ATTACHMENT TO LICENSE AMENDMENT

AMENDMENT NO. 3 TO FACILITY OPERATING LICENSE NO. DPR-51

CHANGE NO. 1 TO TECHNICAL SPECIFICATIONS

ARKANSAS NUCLEAR ONE, UNIT 1

FIG. 4-5
CHANGE 3

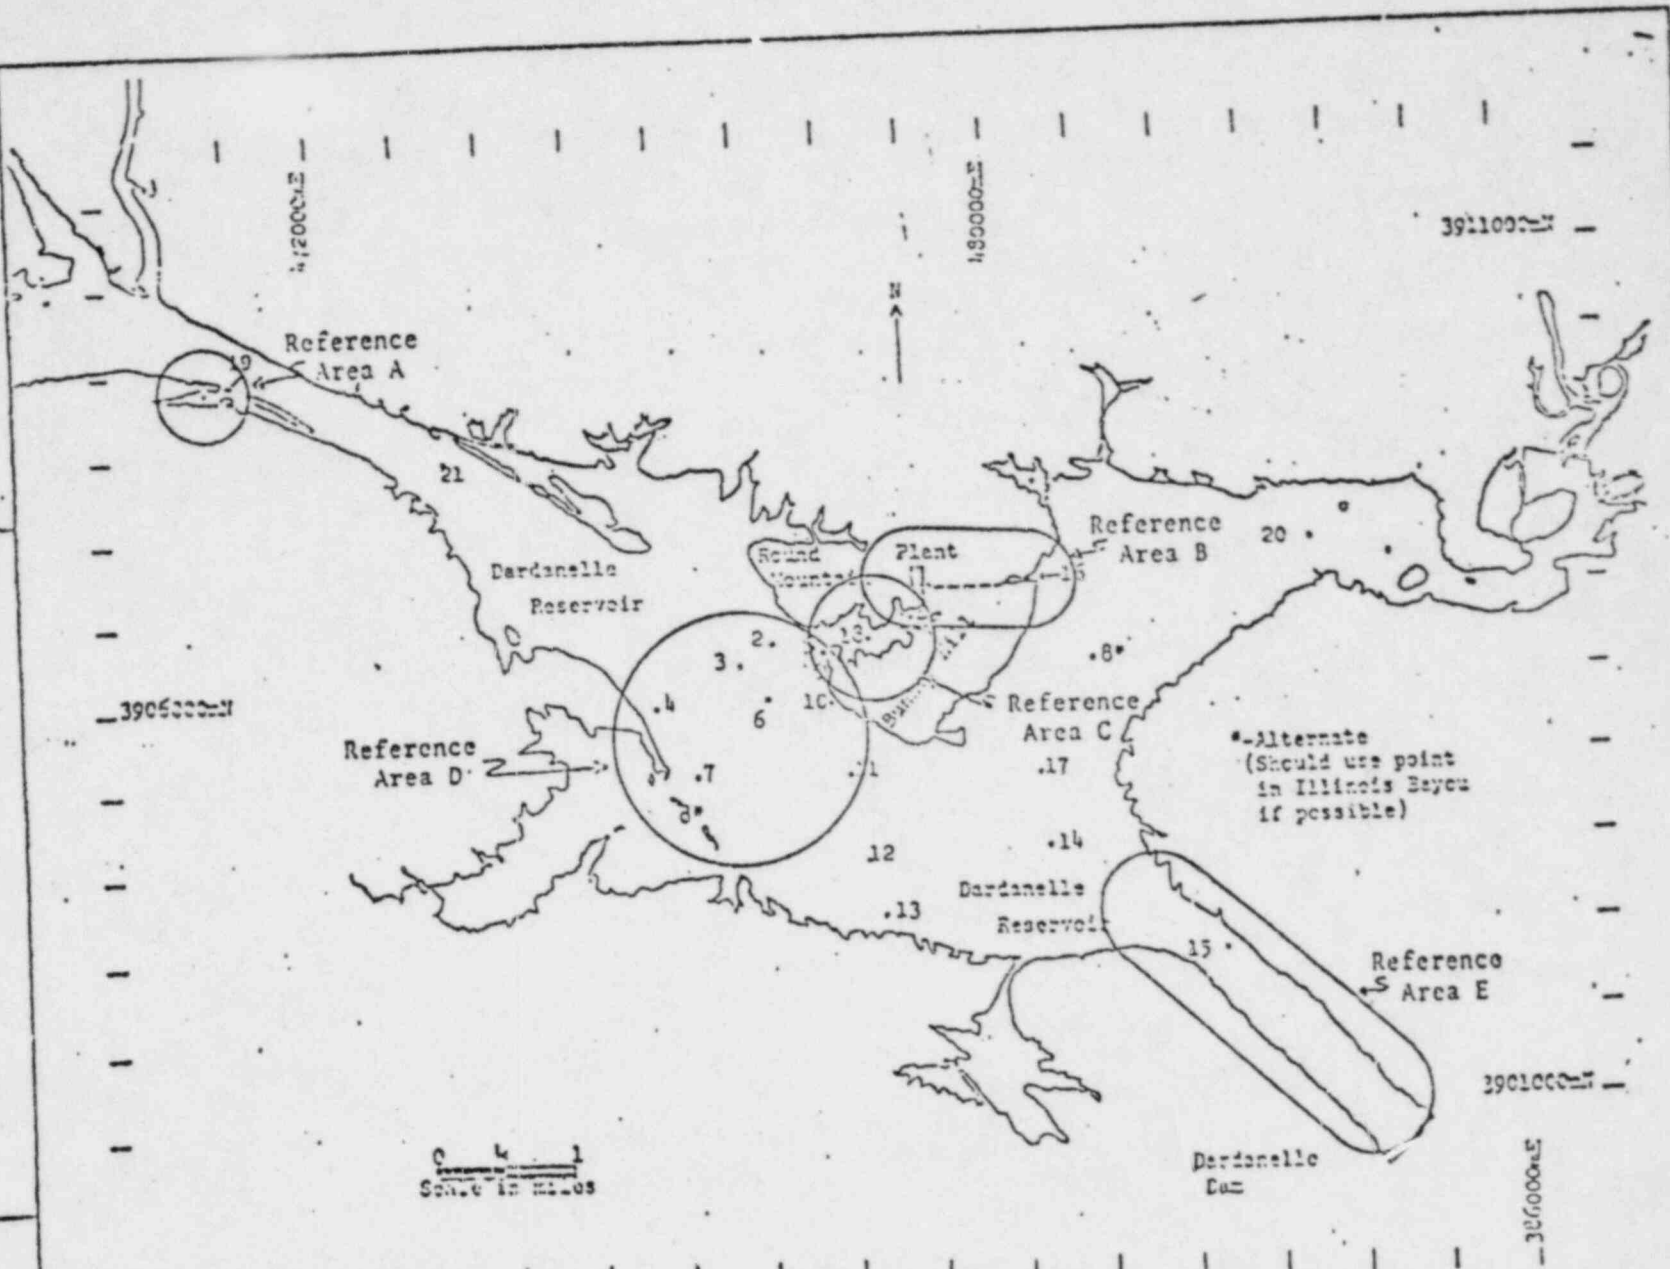
A map of the survey area showing sampling locations is presented in Figure 4-3. The type and frequency of field sampling shall be as presented in Table 4-3.
